## CHARGING SOCKET EMERGENCY RELEASE DAMAGED

I01 (i3 & i3 REx)

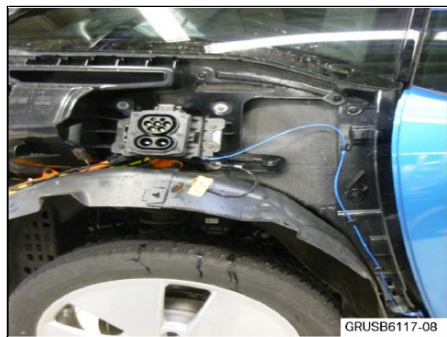
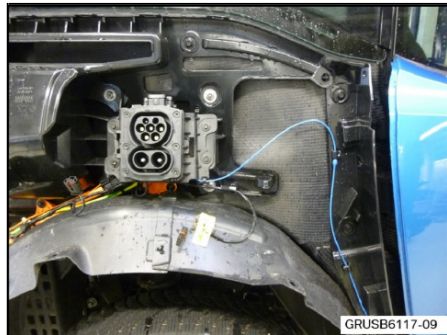
The tensioning strap of the emergency charging socket release (2) has been damaged.

Possible reasons for damage to the emergency release tensioning strap are:

- Excessive force was required to operate the emergency release
- Improper routing of tensioning strap
- Component failure

Replace the supporting strip. The supporting strip has been improved to help the cable glide easier  
Replace the tensioning strap.

Note: During this process, install a new tensioning strap, routing as shown below.
